6. Elizabeth Powell **12-5445** 71 Cliff Road Spa, hardscape, wall, & drive 30/160 Atlantic Landscaping

HDC Landscape Plan

Landscape at  
71 Cliff Rd  
Nantucket, Ma. 02554

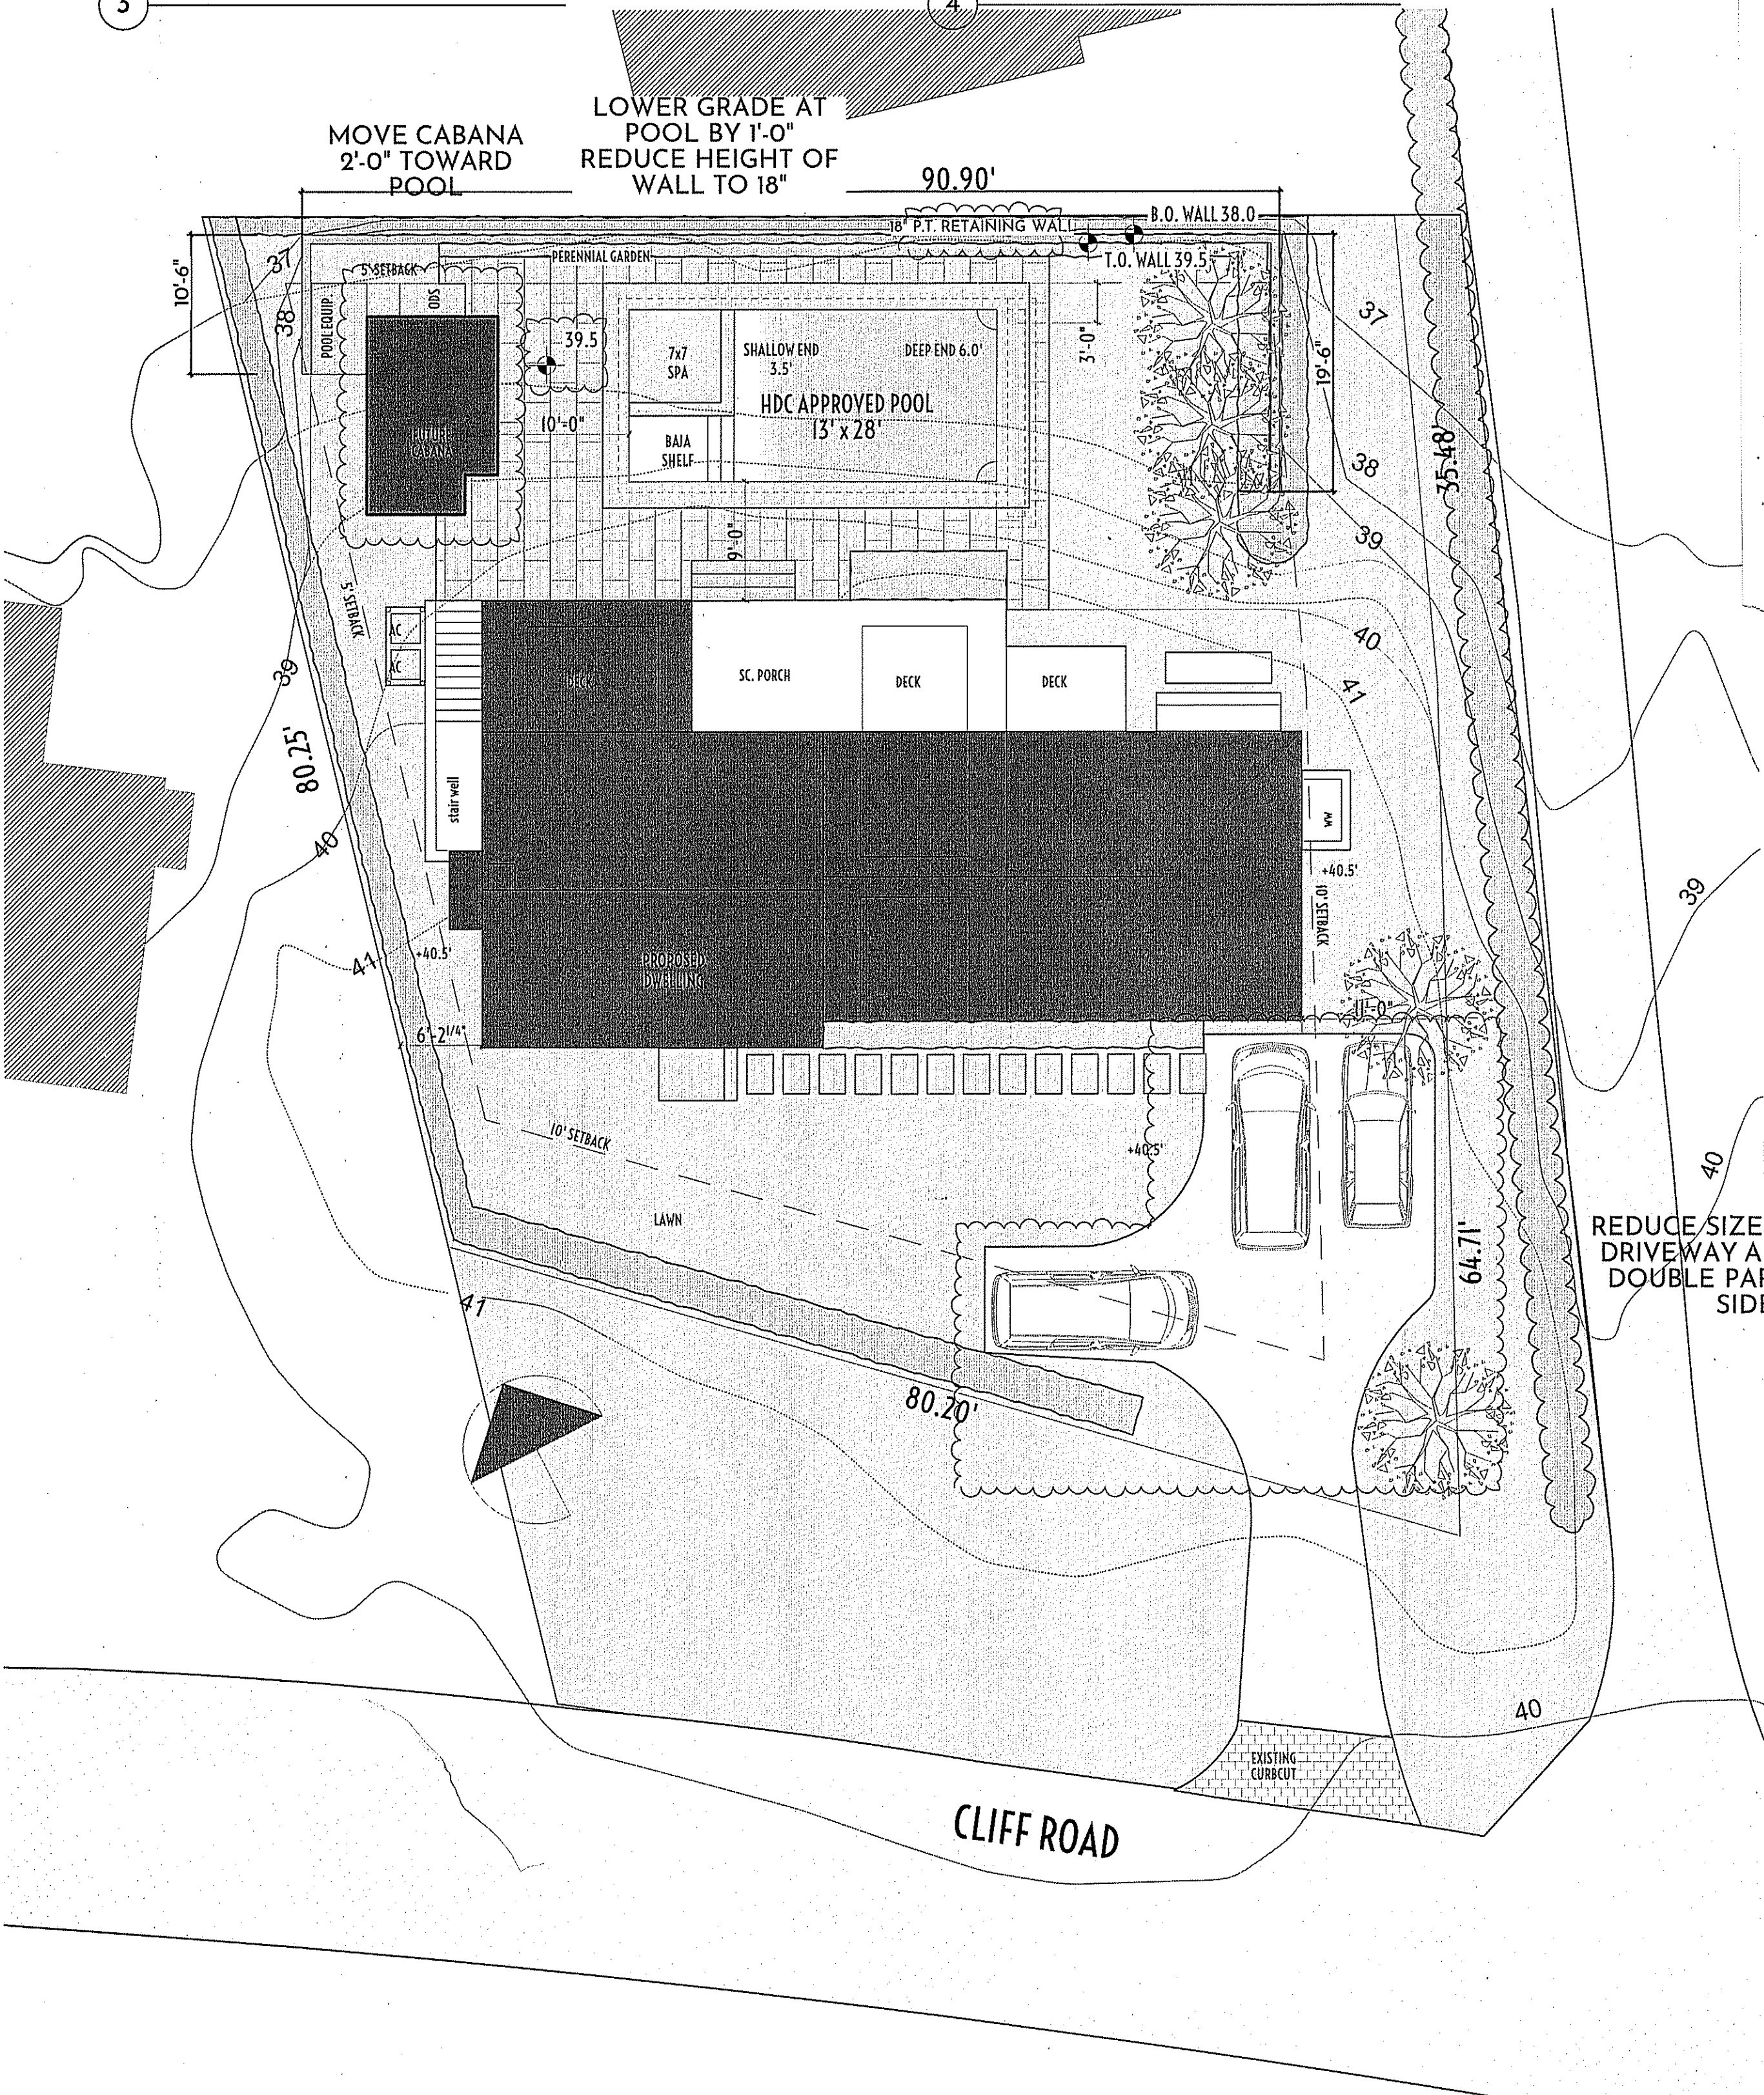
**Welch** – He'd prefer the pool were closer to the house. His main concern is the 36" wall; the lot is being terraforming to create a platform for the pool; he's opposed to the retaining.

**Coombs** – Agrees with Mr. Welch. Berms stop the natural flow of water; that is detrimental to everyone. She'd like to see more grass lawn; this looks heavily hardscaped.

**Camp** – The house is oversized for this lot and the agenda is being squeezed in. A 36" retaining wall is not appropriate. Okay with the spa and shelf within the pool. The driveway and parking in front of the house is too large and inappropriate; it should be pared down.

**Oliver** – She has the same concern about the parking; it should go straight in with a turnaround. Regarding the retaining, it's less than optimal; suggested they step-down from the house; that lowers the pool area so less needs to be retained; that would accommodate higher hedges.

Motion **Motion to Hold for revisions. (Coombs)**  
 Roll-call Vote Carried 4-1//Coombs, Oliver, McLaughlin, and Camp-aye; Welch-nay Certificate # **HDC2021-12-5445**
